Product Change Notification / SYST-30GUOE517

ERRATA - PIC18F04/05/14/15Q41 Silicon Errata and Data Sheet Clarifications

Description of Change: Adding silicon revision E0. Adding silicon errata 1.4.3, 1.4.4, 1.4.5 and 1.9.1.

1.6 Module: Universal Asynchronous Receiver Transmitter (UART)**1.6.1 UART TXDE Signal May Go Low Before the STOP Bit Has Been Entirely Transmitted**

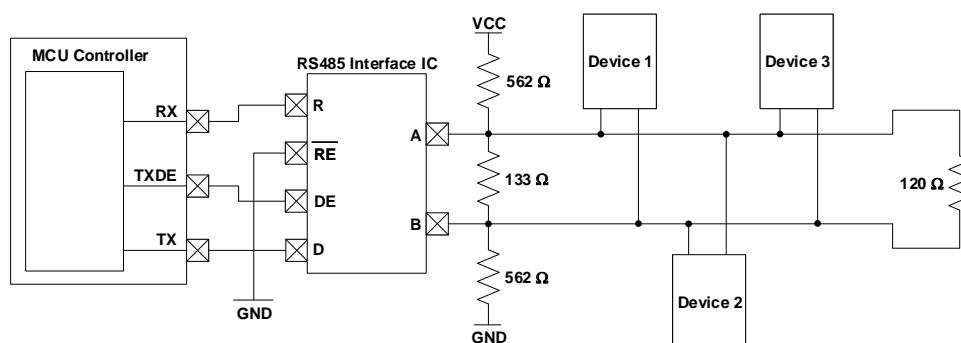
The UART Transmit Drive Enable (TXDE) signal could potentially transition into a low state before the UART STOP bit has been entirely transmitted due to the effects of parasitic capacitance on the TX line. In some applications, this could result in communication being prematurely terminated due to the TXDE bit going low before the STOP bit has had enough time to settle.

To ensure that the STOP bit settles into its final logic state before the TXDE signal transitions low, a biasing circuit can be implemented. A biasing circuit allows the TX line to either be driven high or low, rather than being left in a floating tri-state mode where prolonged rise or fall times could lead to communication being disrupted. This bias circuit should only be implemented on one end of the serial bus, and a termination resistor should be used on the other end. The figure below shows an example of a bias circuit that can be used to achieve this.

Please note that the resistor values used in this circuit are recommendations, and that the actual resistor values required may vary based on the application.
